CITY OF ALBUQUERQUE

**RE: 6715 High Place Ct NW
Grading and Drainage Plan
Engineer's Stamp Date: 3/24/25
Hydrology File: D11D015
Case # HYDR-2025-00094**

Based upon the information provided in your submittal received 3/24/2025, the Grading plan is **approved** for Building Permit and Grading Permit. Please attach a copy of this approved plan in the construction sets for Building Permit processing along with a copy of this letter.

ENGINEER'S SEAL	LOT 32 BLK 3 THE HIGH RANGE AT TAYLOR RANCH 1 6715 HIGH PLACE CT.	DRAWN BY DEM
	GRADING AND DRAINAGE PLAN	DATE 3-21-25
3/24/25		SHEET # C1
DAVID SOULE P.E. #14522	RD BOX 53204 ALBUQUERQUE, NM 87199 (505) 321-8099	JOB #

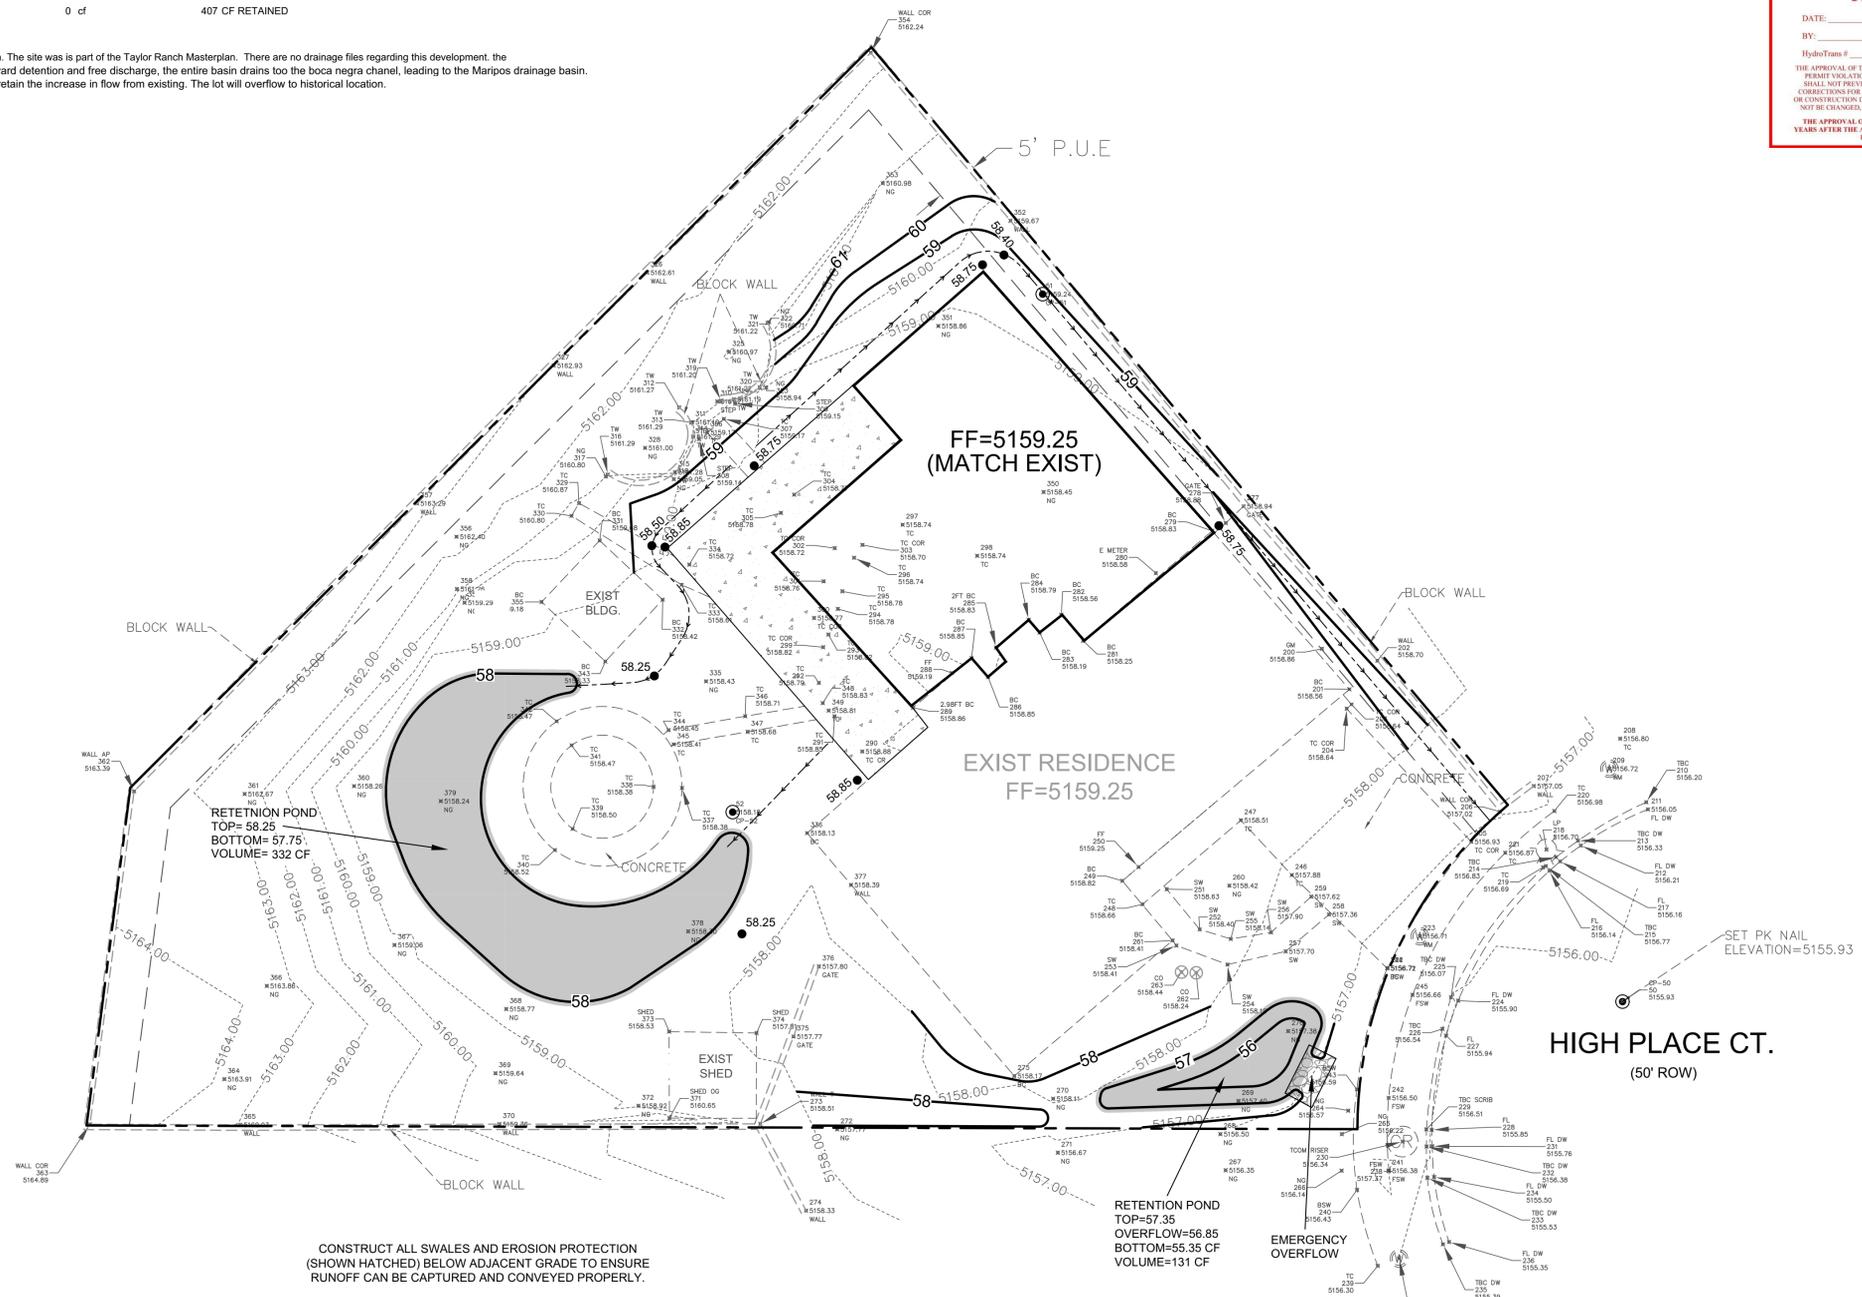
1. Engineer's Certification, per the DPM Part 6-14 (F): *Engineer's Certification Checklist For Non-Subdivision* is required.
